ANNUAL CCR SURFACE IMPOUNDMENT INSPECTION			
<b>Facility Name:</b>		Cleco Brame Energy Center	
<b>Address:</b>		275 Rodemacher Rd. Lena, LA	
<b>Surface Impoundment Name :</b>	Bottom Ash Pond	<b>Owner:</b>	Cleco Power LLC
<b>Surface Impoundment ID:</b>	P-0005R1	<b>Operator:</b>	Cleco Power LLC
<b>Nearest City:</b>	Boyce	<b>Parish:</b>	Rapides
<b>Inspector:</b>		James C. Van Hoof, P.E.	
<b>Company:</b>		Providence Engineering & Environmental Group LLC	
<b>Date of Inspection:</b>		12/17/2020	
<b>Weather at Time of Inspection:</b>		Sunny, Cool	
DESCRIPTION OF THE OPERATION OF THE SURFACE IMPOUNDMENTS:			
<p>The Brame Energy Center's Bottom Ash and Fly Ash surface impoundments are designed to accept the coal combustion residual (CCR) byproducts derived from burning of the Unit 2 coal for the generation of electricity. The ponds are classified by the Louisiana Department of Environmental Quality (LDEQ) as Type I Surface Impoundments. Water from the Fly Ash surface impoundment is pumped into the Bottom Ash impoundment which discharges by means of three pumps that discharge the wastewater through the outlet pipe on the western end of the pond. This water discharges into Lake Rodemacher via

**Bottom Ash Pond**

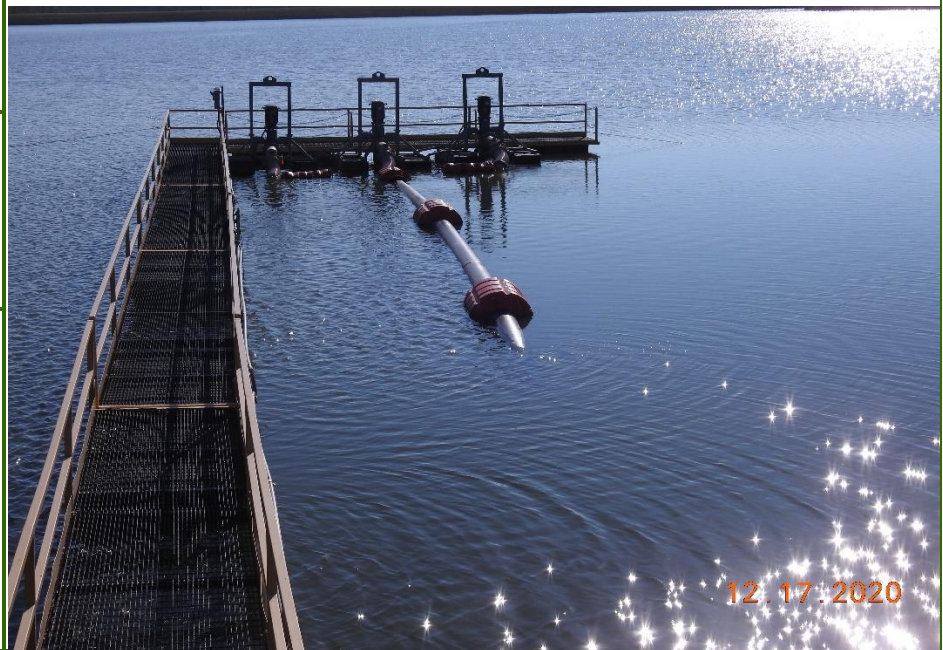
Floating pump structure in Bottom Ash Pond.
